VALUE ENGINEERING REPORT

CR 665 (Carbondale Road) / I-75 Interchange
Project No. IM-STP-75-3(208) Whitfield County
PI No.: 610890

October 23, 2007

MACTEC Engineering and Consulting, Inc.
3200 Town Point Drive NW, Suite 100
Kennesaw, GA 30144
(770.421.3346)

ITEM N^o: A1
CLIENT: GDOT
Sheet 2 of 6

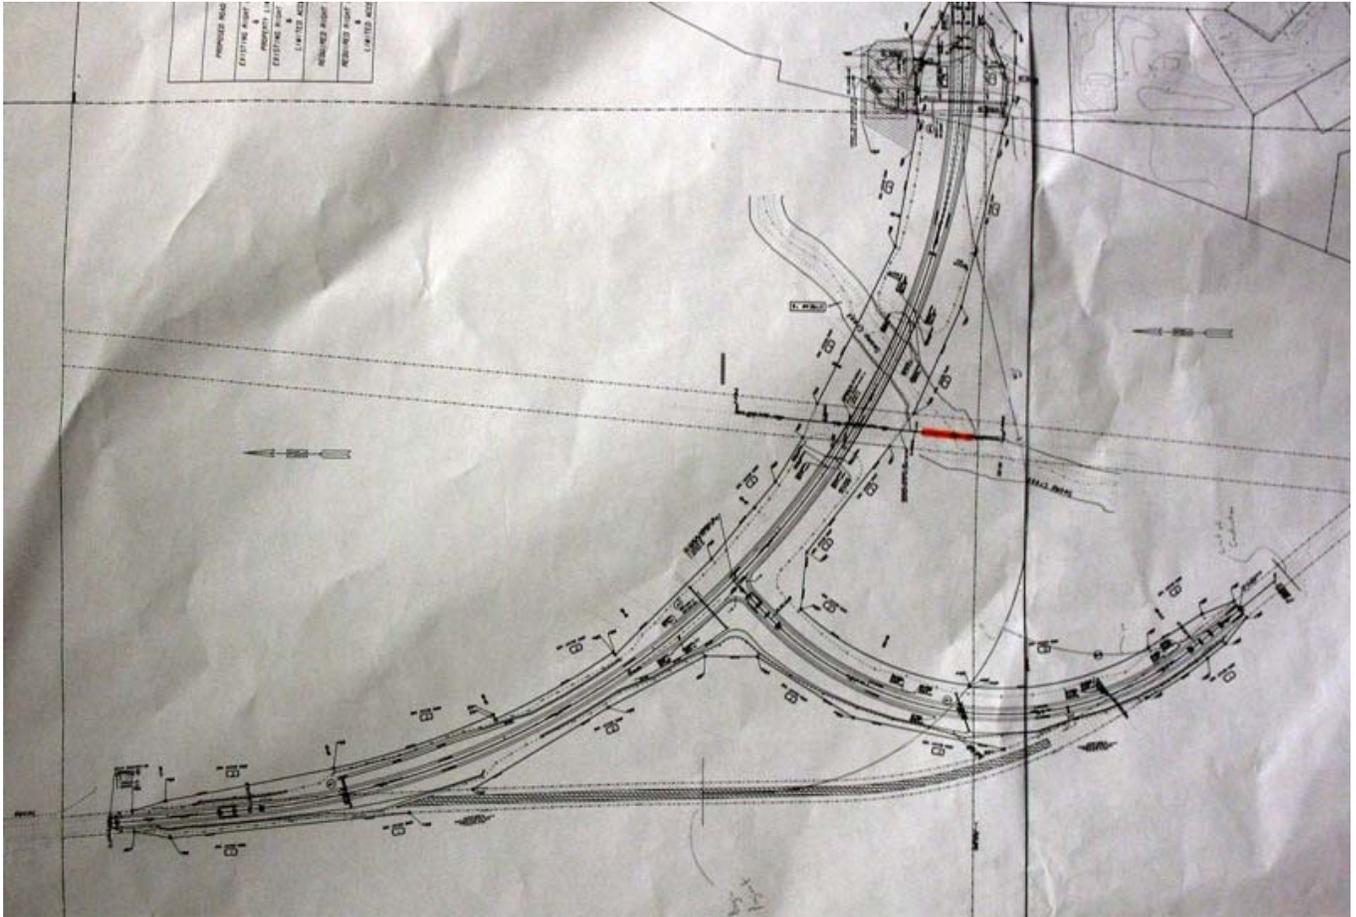
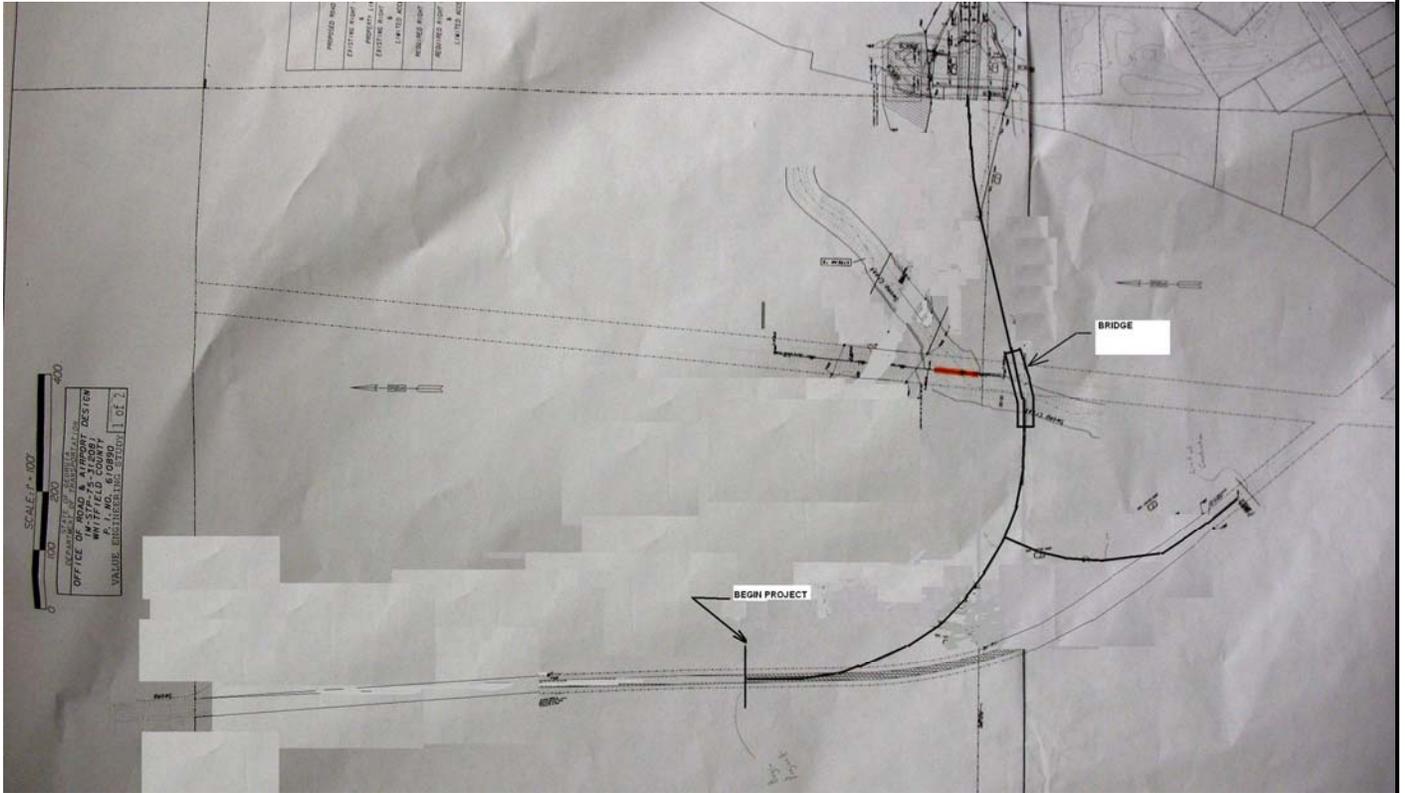
This project includes approximately 7,600 feet of roadway along Carbondale Road. (See sketch).

Reduce roadway to 6,700 feet as shown on the attached sketch.

The proposed revisions reduce the project limits to reduce construction costs and R/W costs. The proposed design makes no noticeable sacrifices to the functional aspects of this project.

ITEM N^o: A-2
CLIENT: GDOT
Sheet 2 of 4

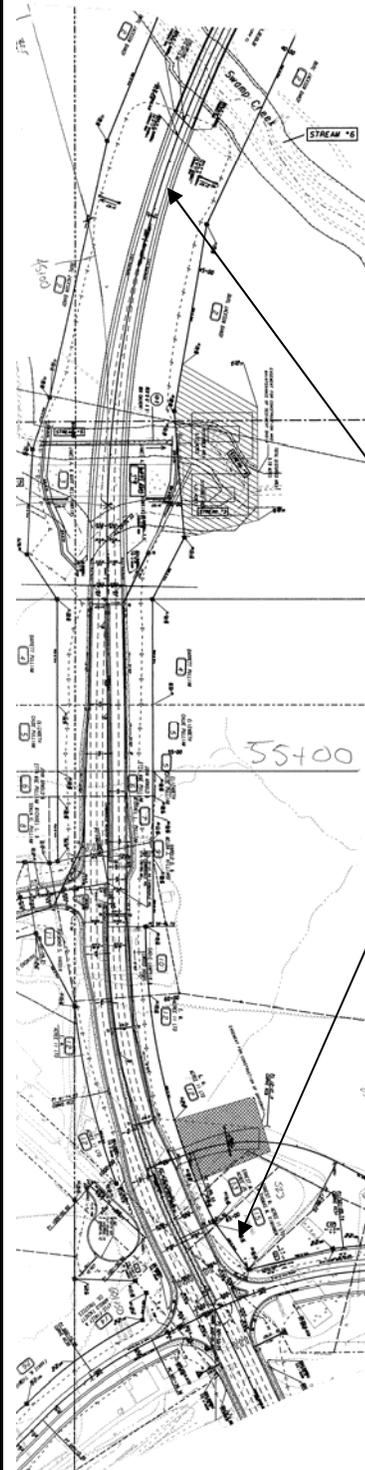
Original Concept widens CR665 on the west side of I-75 as it approaches the bridge for approximately 2200 feet

The proposed condition would eliminate the widening to 4 lanes and retain a 2 lane section all the way to the interchange.

The traffic volumes on Carbondale Road on the west side of I-75 do not warrant a 4 lane section based on capacity requirements.

Proposed Condition eliminates the 4 lane condition on the west side of I-75

Retain a 2 lane section through this area

ITEM N^o: B-1
CLIENT: GDOT
Sheet 2 of 6

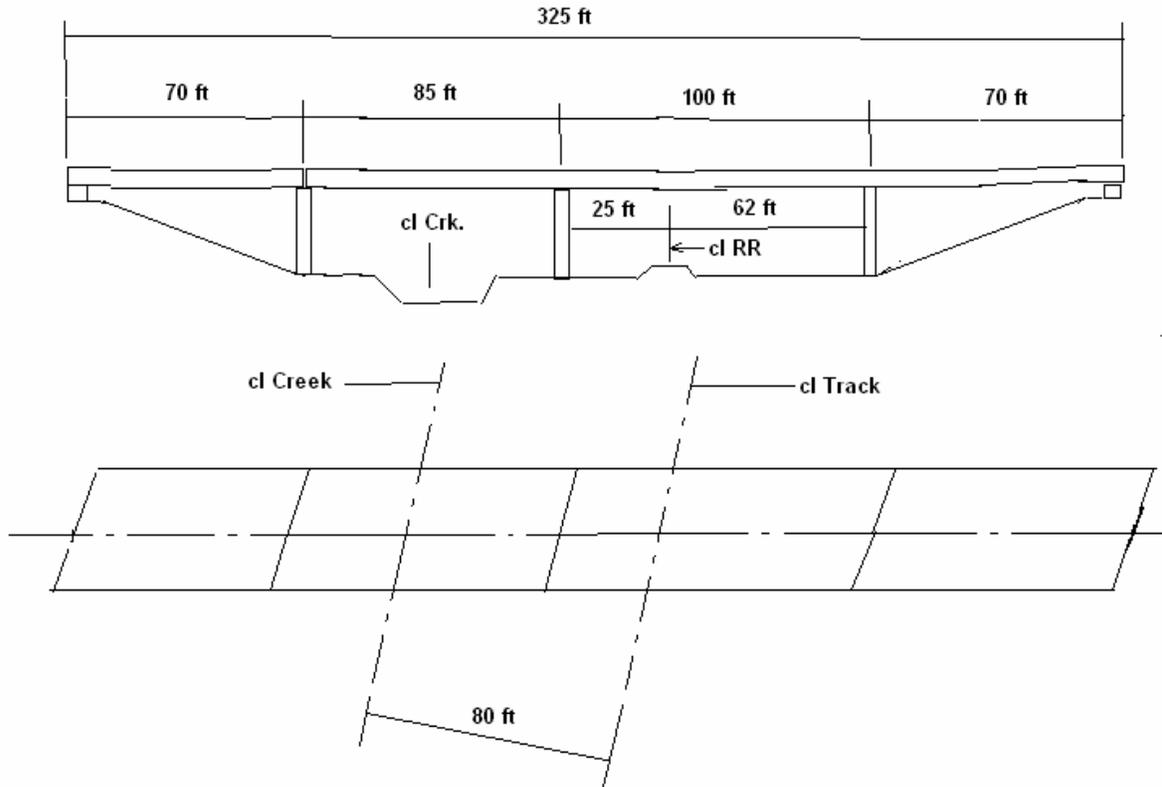
The original concept for the bridge crossing of the NS Railroad and Swamp Creek is to the north of the existing railroad trestle. The bridge is on a horizontal curve and requires skewed bents at the creek and railroad crossing. The overall bridge length is 453 feet.

Shift the alignment to the south of the existing railroad trestle crossing of Swamp Creek and cross the rail road bridge and creek where they are in closer proximity to each other. (See Sketch) See also A-1.

This idea was previously suggested by GDOT Bridge Hydraulics to Road Design. (See Attachment #1). Road Design said that they could not shift to the south because of a conflict with a church and cemetery. We believe this to be the Swamp Creek Baptist Church and cemetery. There was a confusion because of where they were in the alignment process that realigning for a southern crossing would impact the church. Based on the current alignment, a shift to the south at approximately station 50+00 then crossing the creek and railroad seems feasible with no significant impacts. In this change, the stream will be on the west side of the rail road track. Savings shown is for bridge costs only.

1. The crossing south of the railroad trestle is much closer to a 90 degree crossing for the railroad and swamp creek, reducing the geometric complexity of the bridge.
2. The creek and the railroad track are running roughly parallel to each other resulting in a much shorter bridge.
3. The southern crossing of the creek and railroad reduces the length of tie in required along Dug Gap Road. (See Idea No. A-1)

B-4
Pg 2/5

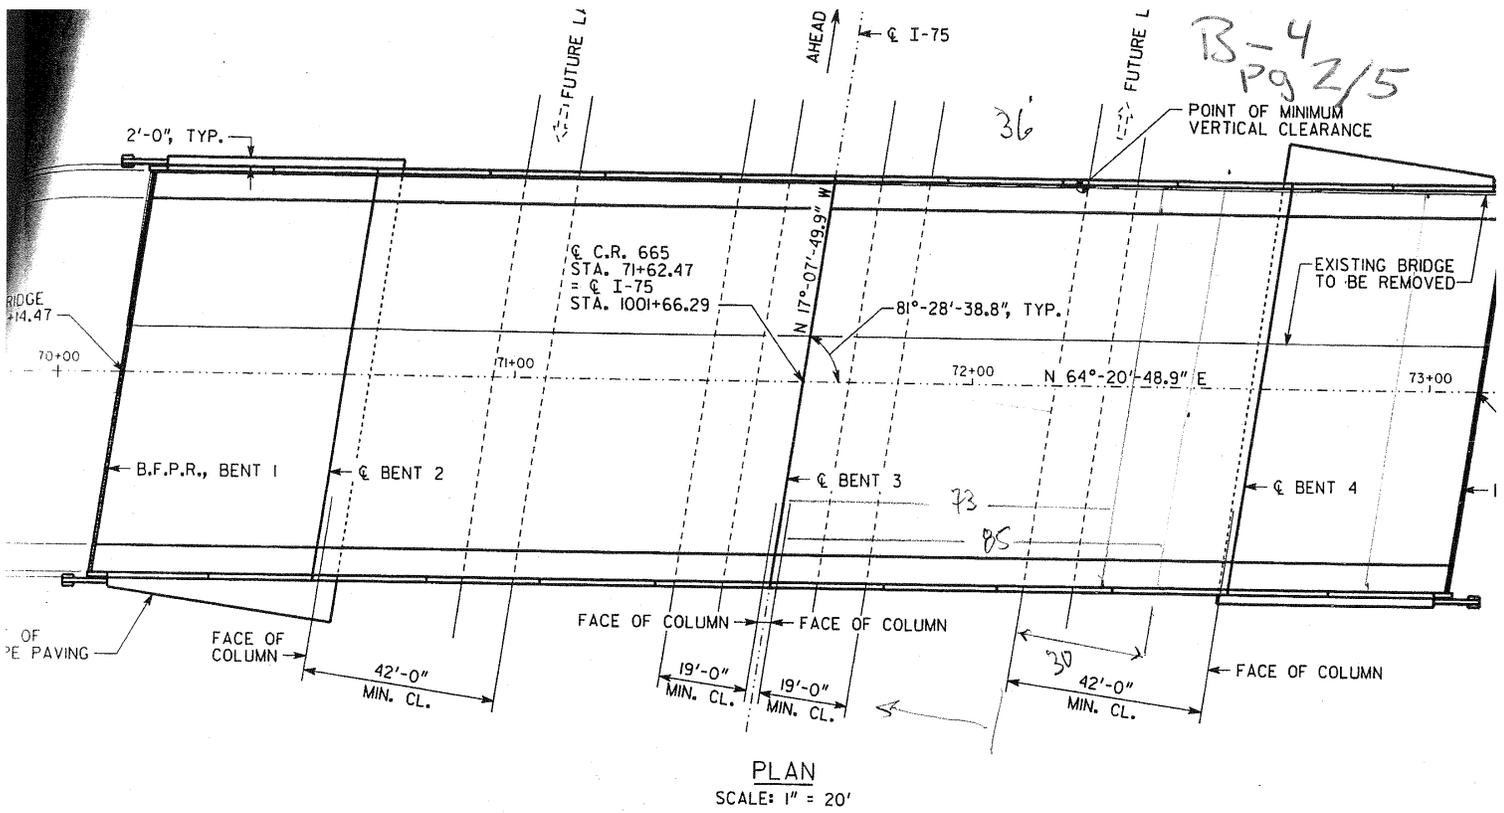
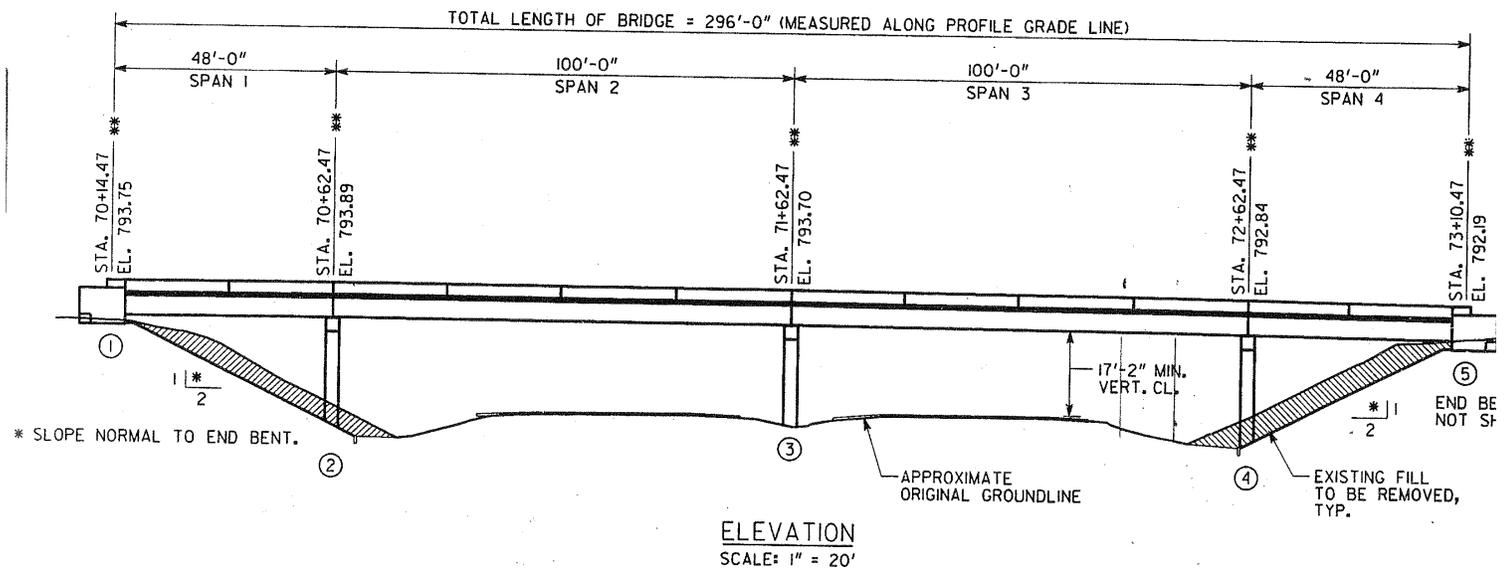
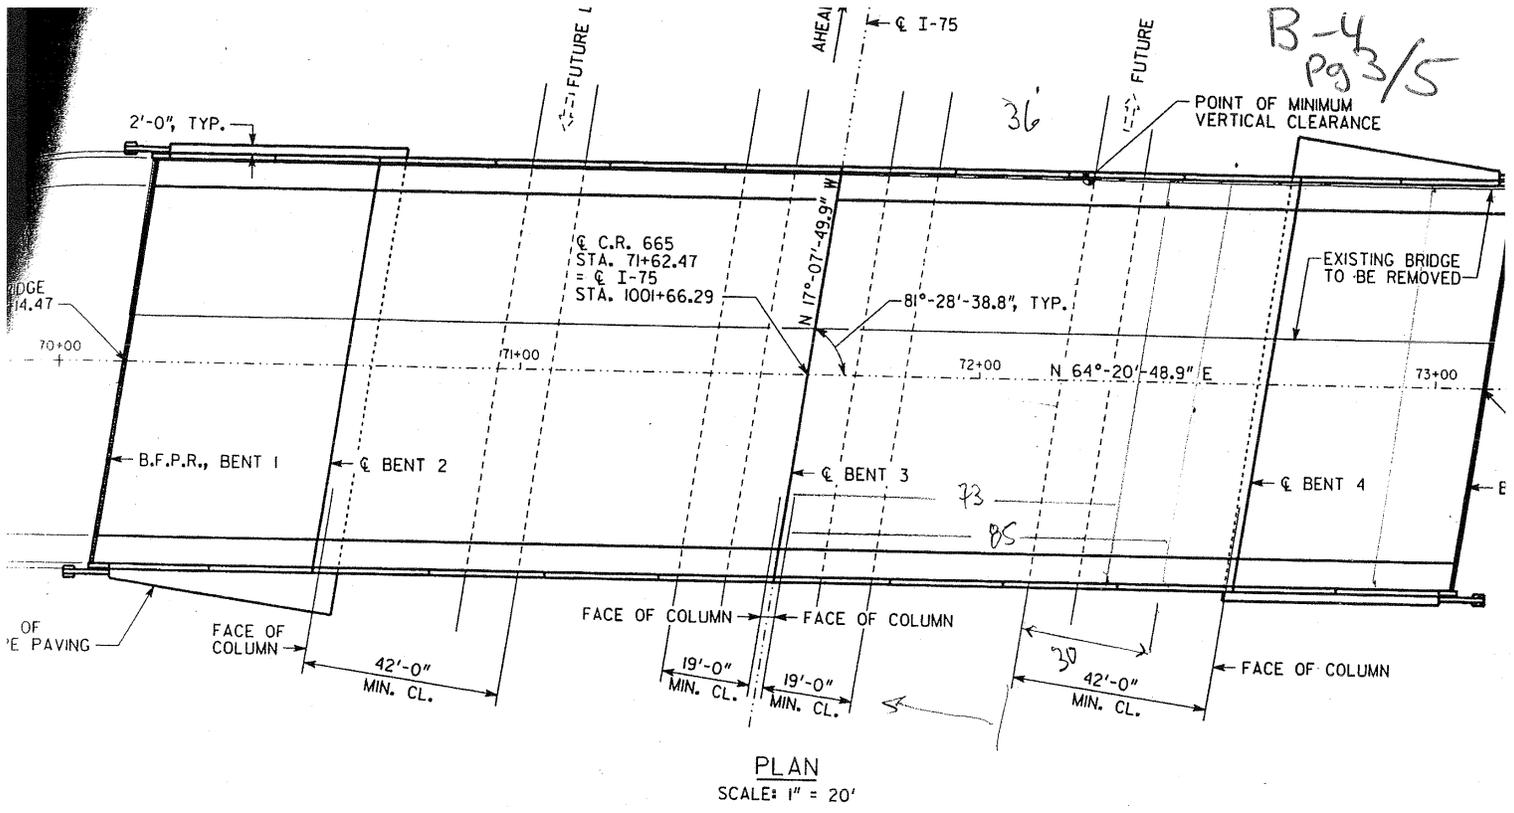
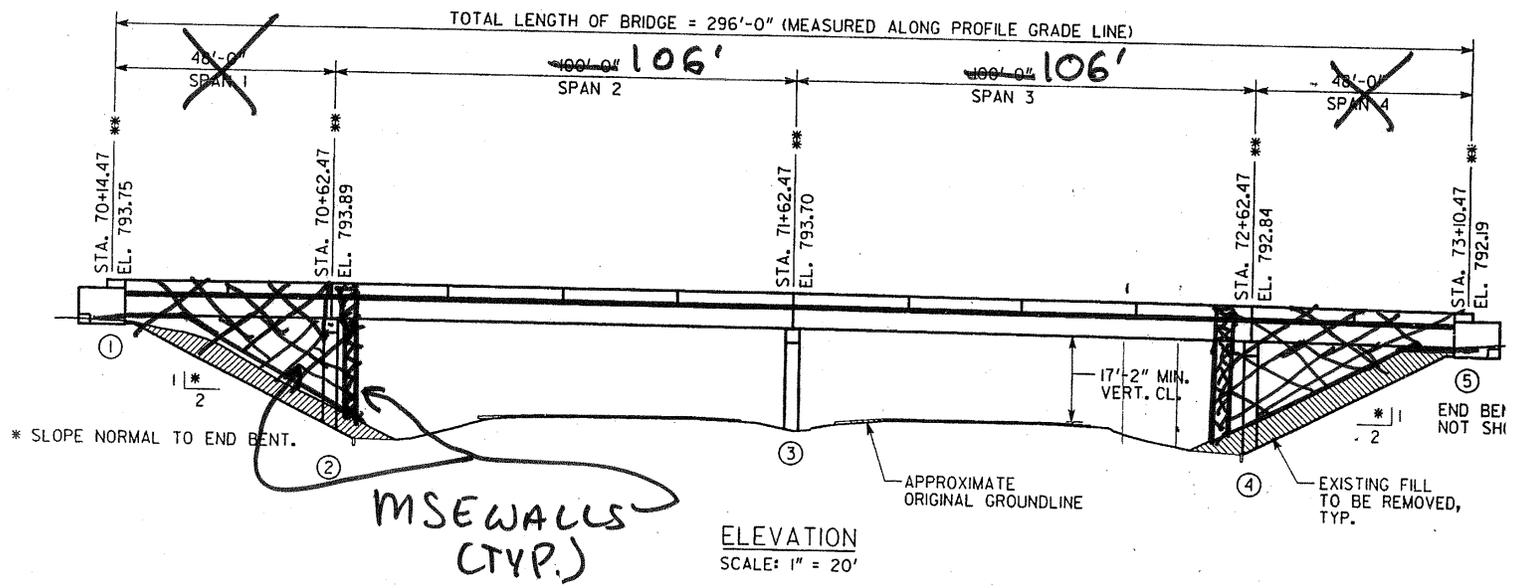
Bridge #2 (CR 665 over I-75) consists of four spans (48 + 100 + 100 + 48) with spill thru abutment and slope paving being provided on the ends.

Eliminate the end spans and provide these with MSE wall abutments. The center spans will be increased to 106 feet each.

The proposed change will shorten the bridge length with a net savings as shown below. The new bridge length is 212 feet.

ITEM N^o: B-401

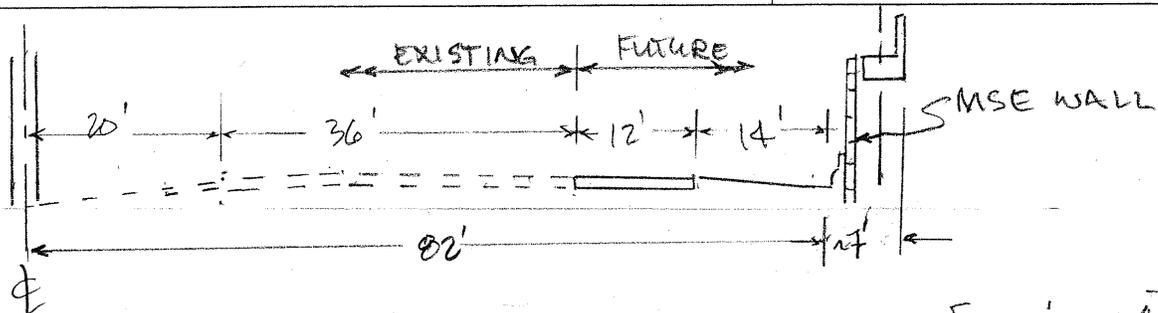
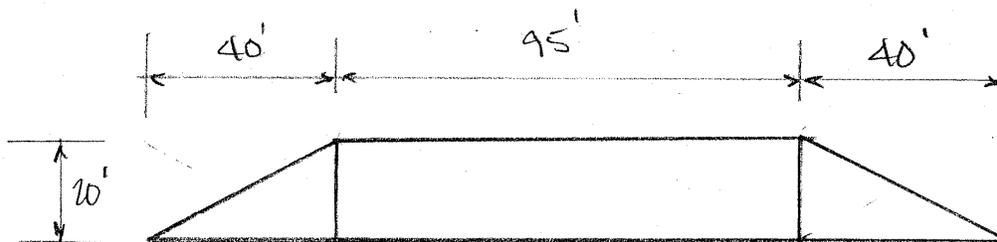
Eliminate the end spans and provide these with MSE wall abutments. Do not allow for the 30 foot clear zone as shown in the original concept. Use guard rail / barrier to protect MSE wall. Use 2-90 foot center spans in this scenario (See sketch).

The proposed change will shorten the bridge length with a net savings as shown below. This concept allows for an additional reduction in bridge span for a new length of 180 feet.

ITEM N^o: B-4.2
 CLIENT: GDOT
 Sheet 2 of 3

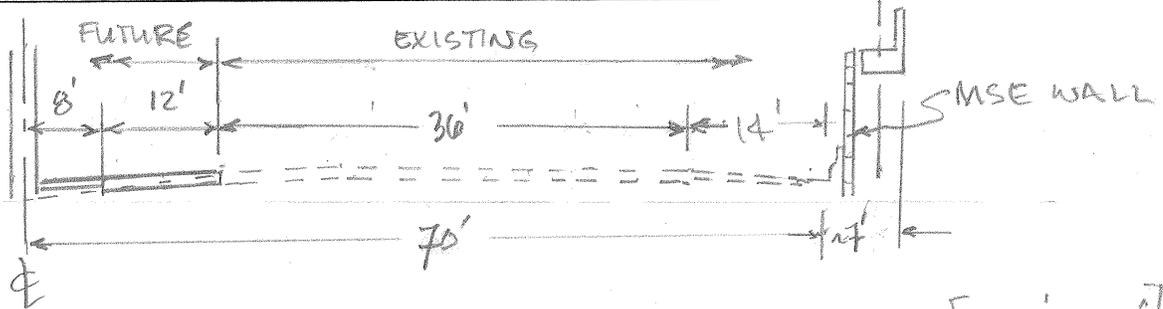
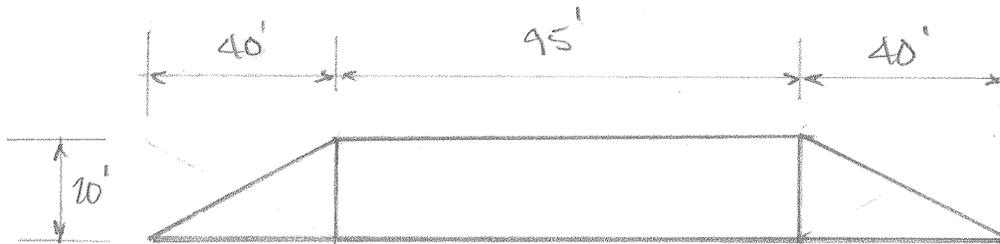
Eliminate the end spans and provide these with MSE wall abutments. Do not allow for the 30 foot clear zone as shown in the original concept. Use guard rail / barrier to protect MSE wall. Provide for the future widening in the center using column protection and median barrier. Use 2-78 foot center spans in this scenario (See sketch).

The proposed change will shorten the bridge length with a net savings as shown below. This concept allows for an additional reduction in bridge span for a new length of 156 feet.

TYPICAL GRADING AND PAVING SECTION FOR I-75 RAMP TAPER CONSTRUCTION

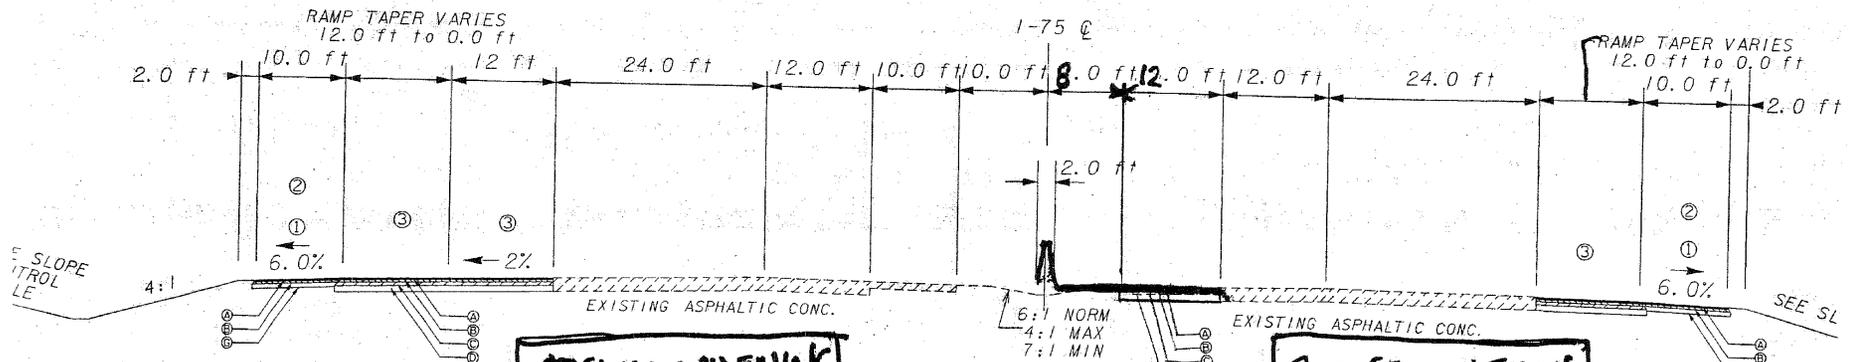
Taper length designs at all four ramps are based on adding an additional lane on the outside of the existing I-75 roadway in the future.

Propose future lane addition be placed on the inside rather than the outside of the existing I-75 roadway. This will allow for reduced taper lengths and minimize shoulder reconstruction. Areas as shown on attached sketch.

Functional classification of I-75 is an “urban interstate principle arterial.” Future lane addition in the existing median is an acceptable section for this classification.
